Subject: Birch Meadow Master Plan Report

Project: **Town of Reading**
Birch Meadow Master Plan

Subject: Community Presentation Follow-up Questions and Comments

Project: **Town of Reading
Birch Meadow Master Plan**

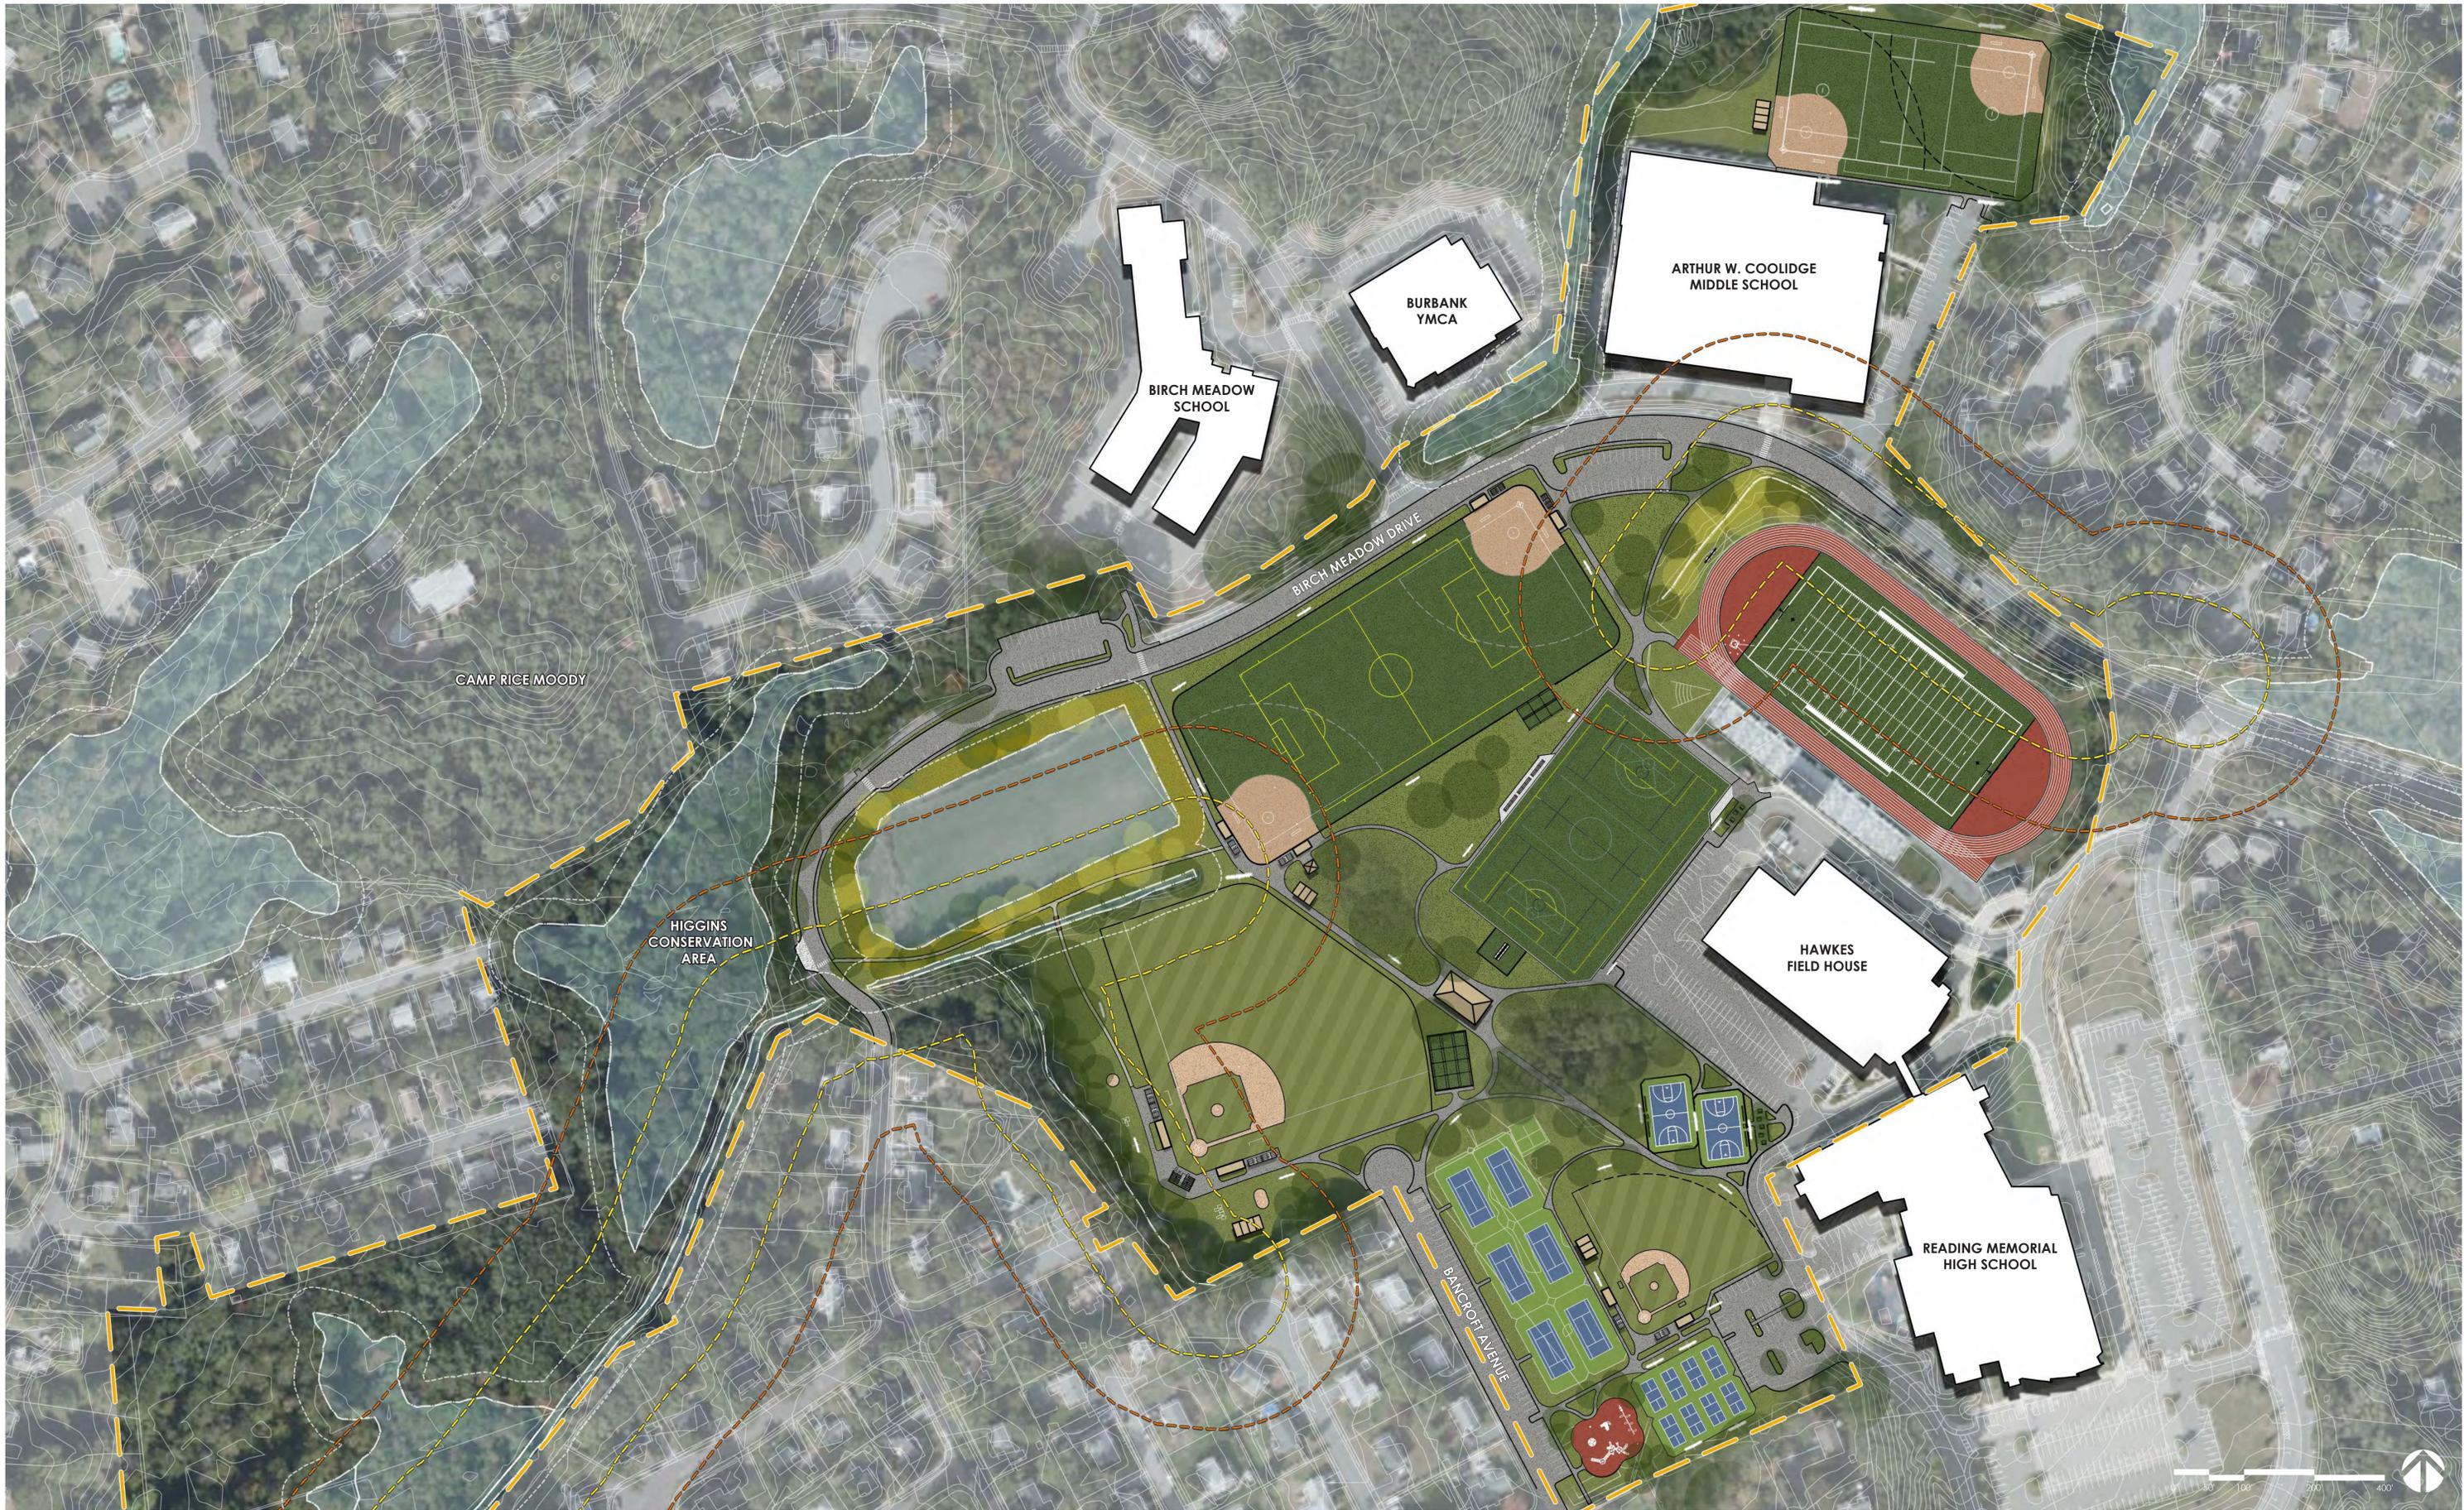
Question/Comment: *We strongly oppose the creation of a formal pedestrian access point to Morton Field from Woodland St. This would significantly impact all the neighbors on the street, creating traffic and parking problems we believe the town would be unable to adequately enforce. It would also impact our property directly. Walker Larsen, 6 Woodland Street.*

- Based on the master plan drawing, the access point would be at the end of our driveway and go along the edge of our property line. Currently there is no formal access at this location. There is a chain link fence in the tree line that runs the length of the Birch Meadow property, perpendicular to the proposed walkway. Directly at the end of Woodland St, an approximate 15-foot section of the fence's top bar has been removed by someone, and the chain link is bent to allow people to step over it. At various times I have considered fixing the fence but assume it will only be taken apart again. Some people do cut through this way by creating a path through the vegetation and stepping over the broken fence. At various times they have also laid logs or other debris in the stream bed at the edge of Morton Field in order to cross the stream. This blocks the water flow, so I tend to remove such debris when I notice it.

- If a formal pedestrian access point is created, we assume it will be a crushed stone or paved pathway with a small bridge over the critical stream bed. If this project is ever proposed, we would like to work with the town on the location of the pathway, and request the town add both vegetative and structural privacy screening to block views into our yard and prevent trespassing. Trash receptacles would also need to be installed at both ends of the pathway. If a formal access point is created, we anticipate it would be heavily used, leading to a significant change in use for all four houses on our small street, and our driveway and yard in particular.

- If a formal access point is ever created, the town would need to add signage at the top of Woodland St (intersection with John Carver), at the bottom by the access point, and potentially at appropriate other spots along the street approved by the neighbors, clearly stating that there is no parking on Woodland St for access to Birch Meadow. It may also be necessary to post such signage along John Carver and on the other side of

Woodland St. Restrictions would need to be enforced and neighbors would need to have a way to notify the appropriate authority of violations.

Upon further review with members of the Working Group, the pedestrian connection at the end of Woodland will be removed from the master plan recommendations and conceptual site plan. The master plan report, however, will recommend that the Town continue to explore opportunities to provide additional pedestrian connectivity from adjacent neighbors to Birch Meadow via boardwalks over protected resource areas.
